# Access Compliance Report

## Public Rights-of-Way

### (Pedestrian Signals)

Intersection ID: N/A	Main Street:	Cross Street: N/A	Location: N/A
ADA ID: 70FB73581720	Signal Type: One Push Button-Non APS	Overall Compliance: No	Severity Score: BTN 1: N/A BTN 2: N/A No BTN: N/A
Codes/Mitigation Info/Possible Solution		Field Measurements/Component Compliance

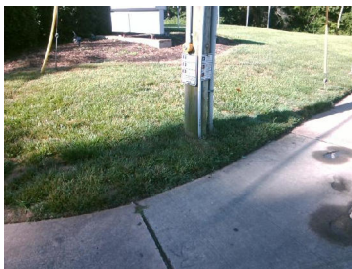
Surveyor Notes: TEXT HT 7/16

PROW/ADA: R410.6, TMUTCD 4e.08, R406.2, R404.7.3

Possible Solutions: Replace Signal Push Button With APS Button on New Post. Remove & Replace Sign.
